**INSTRUMENT INTERFACE DOCUMENT
PART B**

INSTRUMENT "SPIRE"

SCI-PT-IIDB/Spire-02124 issue 3.2 sign off notes.

SPIRE IID-B v 3.2

Figure 5.4-8. HSFCU has webbed feet and looks like:

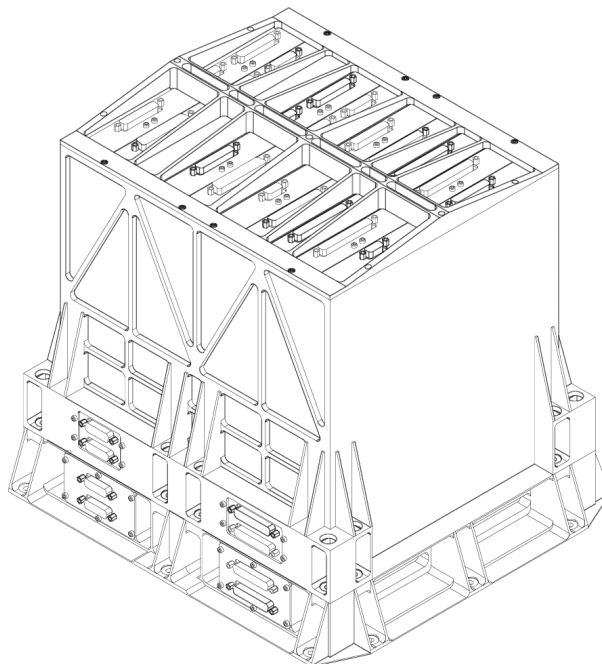
p 5-11

p 5-14

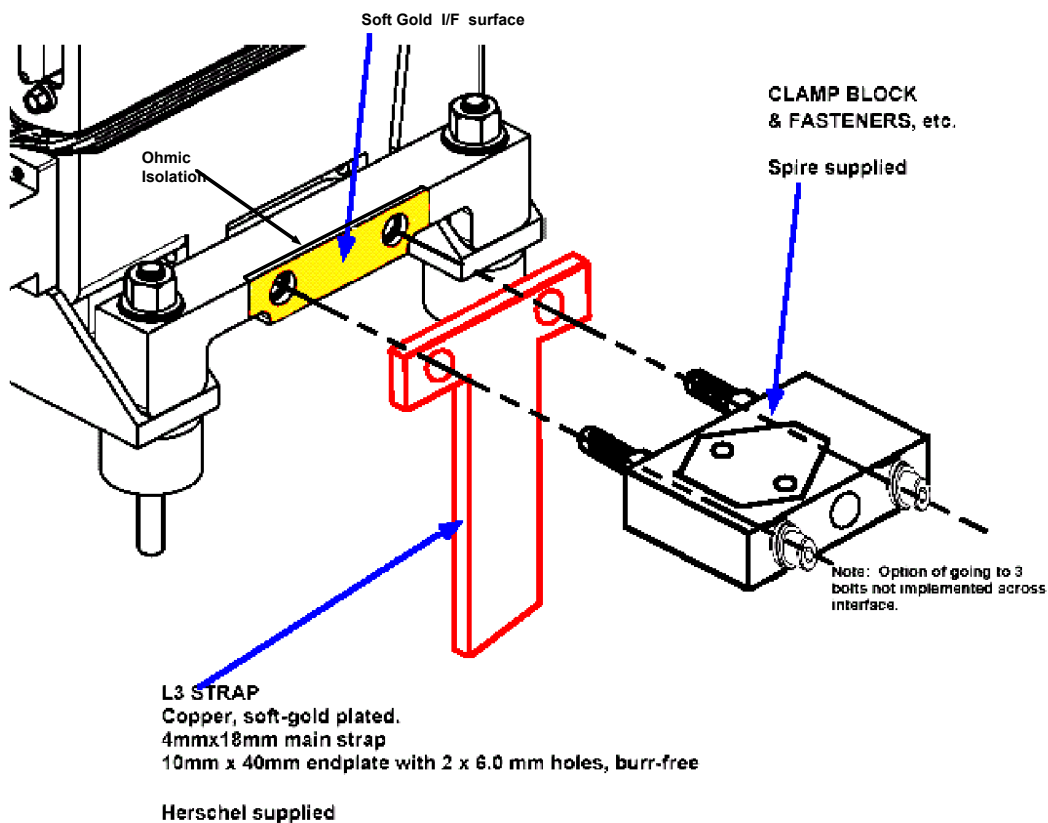
Change words "Kapton Tape" in 7th paragraph to "Ohmic isolation", and drop in this updated diagram:
